1/2.5-Inch 8Mp Digital Image Sensor

MT9E001

Silicon Revision 1 Errata

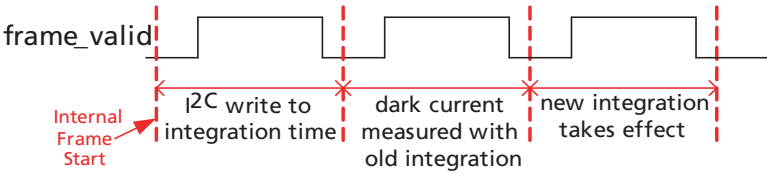
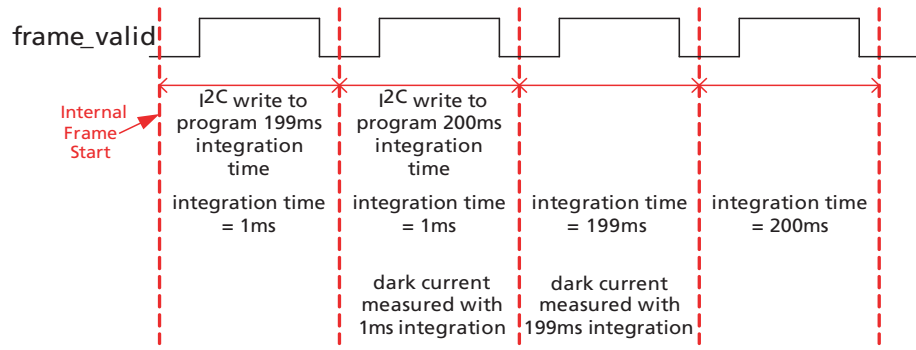
Issue #	Title Description Work Around	Details
2	Title	Dark current compensation.
	Description	<p>An integration time change will take affect on the second frame after the integration time register was programmed. However, the delta dark algorithm will use the first frame after the integration time register was programmed to measure the dark current. Hence, the delta dark algorithm will compensate dark current based on the old integration time instead of the new integration time. This will be noticeable for large integration time changes as the dark level calculated for the new integration time will use the frame prior to when the new integration time was used.</p>  <p>The diagram shows a sequence of four frames. The first frame has an integration time of 1ms. An i2C write to change the integration time to 199ms occurs during the second frame. The dark current is measured at the start of the second frame using the old 1ms integration time. The new integration time of 199ms takes effect at the start of the third frame.</p>

Work Around	<p>The integration time is changed in two successive frames where the first frame's integration time is only slightly different from the second. In this case, the dark level calculated for the second frame uses the prior frame that has a similar integration time, producing a very small difference in dark level. An example would be a change from 1ms to 199ms, and then to 200ms, where the ongoing dark level for 200ms would be calculated from a frame using 199ms. If the gain setting is also being changed, it should not be applied on the first of the two consecutive frames. An example is shown in the graphic below.</p>  <p>The diagram shows a sequence of four frames. The first frame has an integration time of 1ms. An i2C write to change the integration time to 199ms occurs during the second frame. The dark current is measured at the start of the second frame using the old 1ms integration time. The integration time changes to 200ms at the start of the third frame. The dark current is measured at the start of the third frame using the 199ms integration time.</p>
